Access Compliance Report Public Rights-of-Way (Curb Ramps)

Main Street: OCASO_ST Cross Street: JARANO_ST Location: NW

ADA ID: RPRK211124141545 Ramp Type: Type 1 - Perpendicular Diagonal Initial Pass/Fail: Pass Overall Compliance: No Severity Score: 0

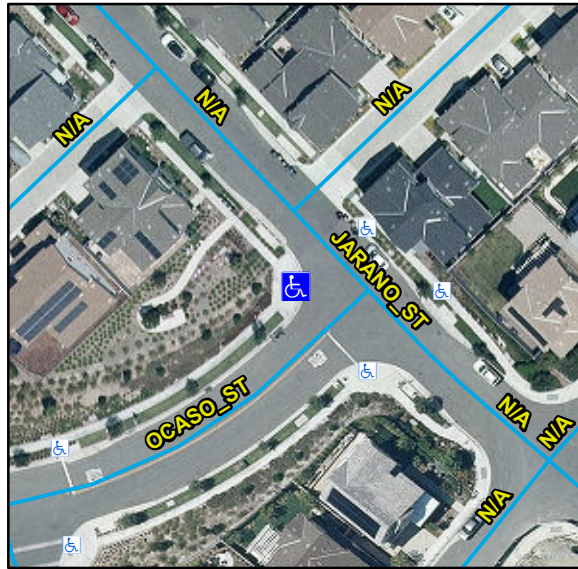
R304.5.3, STD 1115

Remove & Replace Gutter.
